SERVICE BULLETIN

TORQUE TRANSDUCER ELECTRICAL CONNECTOR ONE TIME INSPECTION

Model 600N Helicopters, serial number RN003 thru RN061.
Serial numbers RN003 thru RN047 must be in compliance with Service Bulletin SB600N-018R1 or later revision prior to accomplishing this Bulletin.

Figure 1. Torque Transducer Electrical Connector Location

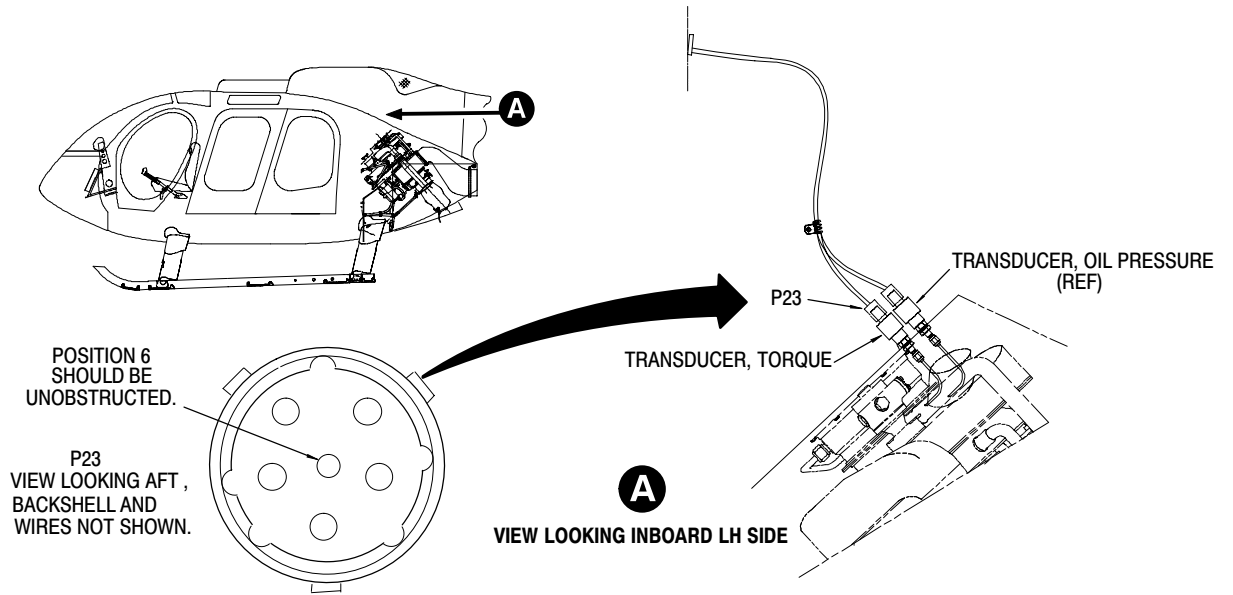
- (1). Remove engine inlet screen (Ref. CSP-HMI-2, Section 71-10-00, Engine Inlet Screen Removal (600N)) or remove particle separator (Ref. CSP-HMI-2, Section 71-10-60, Particle Separator Removal).
(Ref. Figure 1)
- (2). Unplug connector, P23 from torque transducer.
- (3). Remove backshell from connector.
- (4). Verify that center contact position (position 6) of connector is open and unobstructed.
- (5). If contact position is obstructed, remove sealing plug or extract contact.
- (6). Reassemble backshell and connector, and verify that shield terminations are not damaged.
- (7). Install reassembled connector on torque transducer mating connector.
- (8). Install engine inlet screen (Ref. CSP-HMI-2, Section 71-10-00, Engine Inlet Screen Installation (600N)) or install particle separator (Ref. CSP-HMI-2, Section 71-10-60, Particle Separator Installation).
